# United States Patent and Trademark Office

| APPLICATION NO.  | FILING DATE     | FIRST NAMED INVENTOR    | ATTORNEY DOCKET NO. | CONFIRMATION NO. |
|--|-----------------|-------------------------|---------------------|------------------|
| 09/737,770   | 12/18/2000      | In-Duk Song             | 8733.339.00         | 8950             |

| · · · · · · · · · · · · · · · · · · ·   | Application No.                | Applicant(s)  |  |  |  |
|---|--------------------------------|---|--|--|--|
| · Office Action Summary   | 09/737,770                     |   |  |  |  |

#### **DETAILED ACTION**

FIG.2E

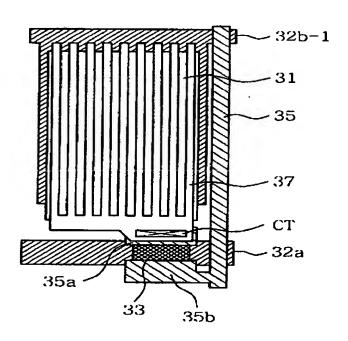
Jeon discloses in Figures 2A-2E, an in-plane switching LCD device comprising: a gate line, 32a, on a first substrate; a data line, 35, on the first substrate, the data line being perpendicular (as illustrated) to the gate line; a common line, 32b-1, on the first

substrate, the common line being parallel (as illustrated) with the gate line and being formed of a metal (Cr for both gate line and common line; col. 2, lines 49-58, especially lines 55-58); a pixel electrode, 37, (ITO; col. 3, lines 18-22) and the common electrode, 31, (ITO; col. 2, lines 64-67) being formed of a transparent conductive material (ITO); and a liquid crystal layer between the first and second substrates (inherent to comprising a LCD device) made by a method that simplifies the process by reducing the mask number.

As to claim 18, Jeon discloses the LCD device of claim 17, wherein a portion of the common line overlies a portion of the common electrode (Figures 2A-2E, especially Figure 2C, and col. 2, lines 49-67, especially lines 64-67).

FIG. 3

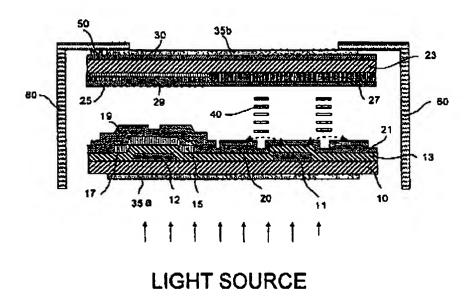
Son teaches in Figure 3, an LCD device, further comprising a light-shielding layer, 25, (Applicant's black matrix) on the second substrate, 23, (para 0029).

Son is evidence that ordinary workers in the art of liquid crystals would find the reason, suggestion, or motivation to use a black matrix on the second substrate to prevent light from leaking around the TFT (first two lines of para 0029).

FIG.1
(PRIOR ART)

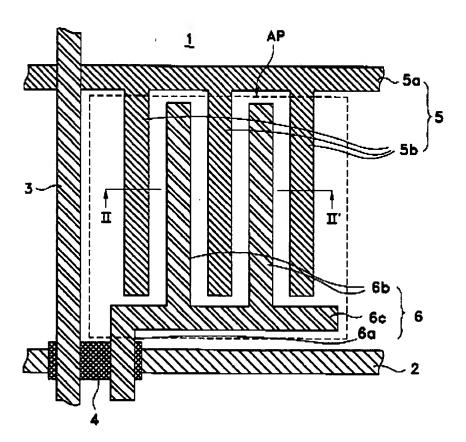
Shin teaches as prior art in Figures 1 and 2 the use of a pixel electrode, 6b, formed of an opaque metal (col. 2, lines 3-6) in order to block a light of the area in which the liquid crystal molecules are not operated in an in-plane switched LCD.

Shin is evidence that ordinary workers in the art of liquid crystals would find the reason, suggestion, or motivation to add opaque metal electrodes in order to block a light of the area in which the liquid crystal molecules are not operated.
